MILWAUKEE HISTORIC PRESERVATION COMMISSION STAFF REPORT

Date	7/6/2026	Ald.	Brower
CCF	260265	Reviewer	Tim Askin
Address	2386 N Terrace Ave	Owner	Aaron Dekosky Jim Pitzen
District	North Point North	Applicant	Brookfield Design Remodel

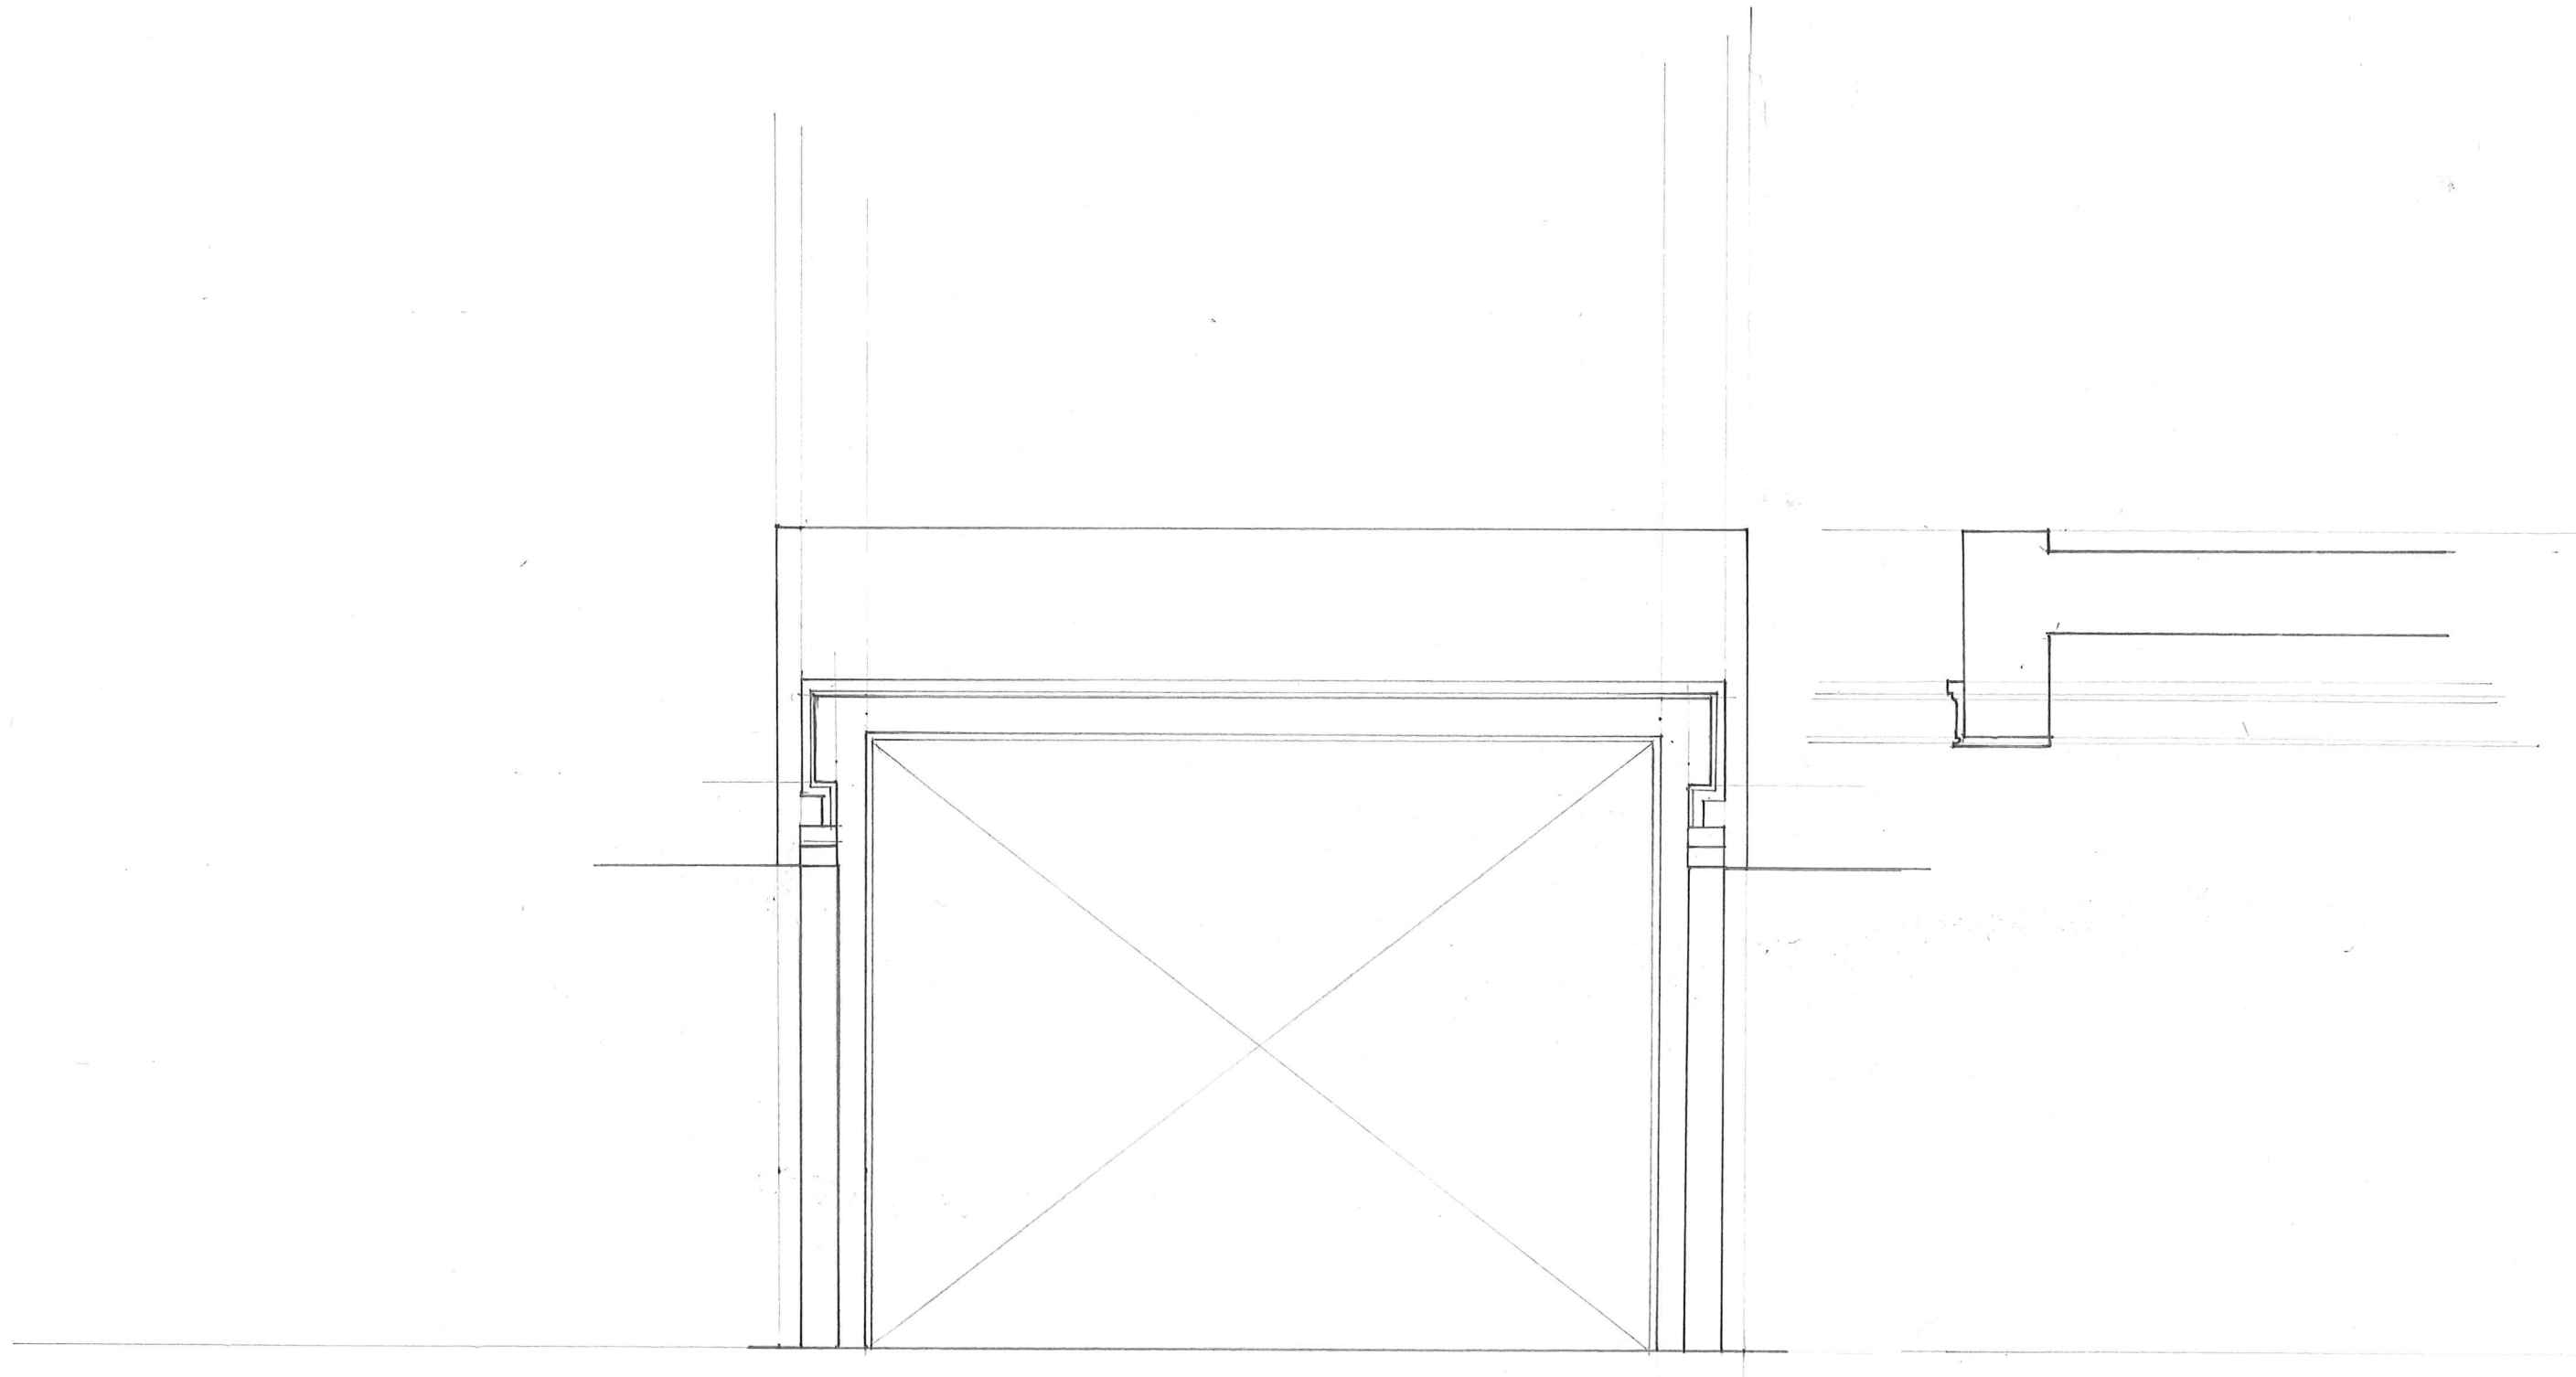
This is unique idea, but not untenable. The design is largely adequate, but needs some trim detailing on the street façade. As drawn, it lacks an identifiable visual top to the structure. While this is probably intended to help minimize the appearance it rather makes the structure seem taller than it actually is. This is easily corrected and design concepts are attached to this report.

1. Add trim detail or cornice to the overhead door surround.

Inspired by Theory of Mouldings. See next page.

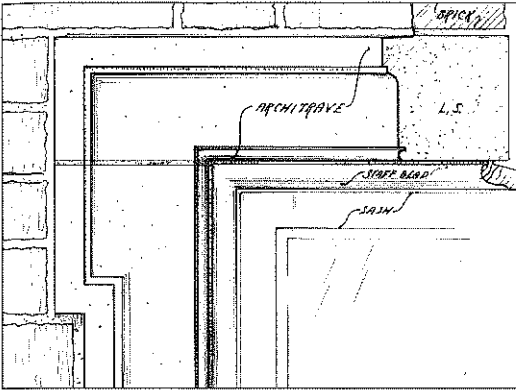
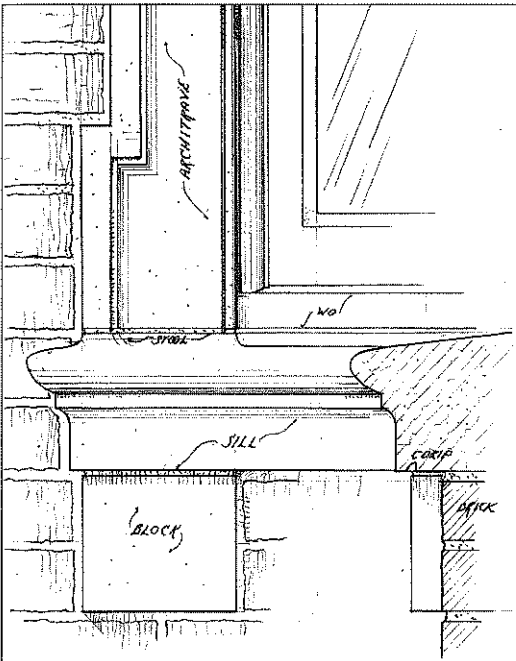
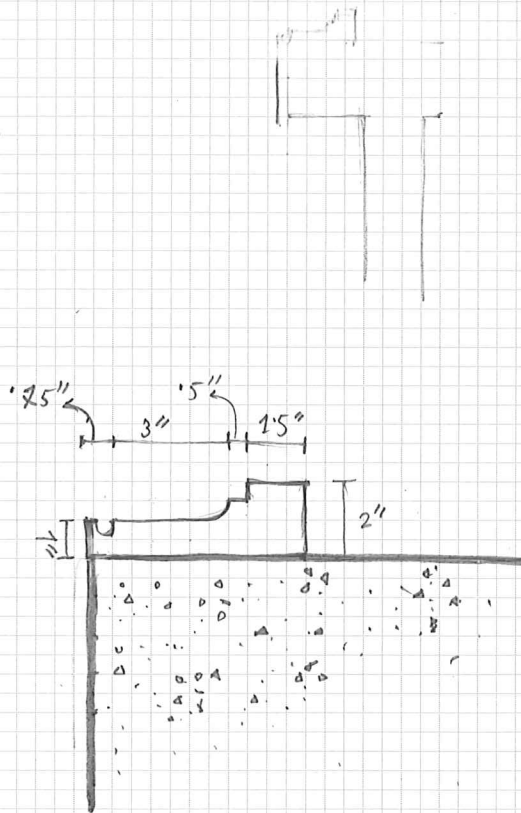
Below and right: Architrave detail (lintel and coursing) at head of window showing crossette, or eared corners. The Tuscan architrave consists of a fillet or tenia (bearing plate between the frieze and the architrave) and a congé (a quarter-round, which serves to separate two members).

Below: Detail of sill supported by block modillion. The mostly straight Tuscan architrave contrasts with mostly curved sill nosing.
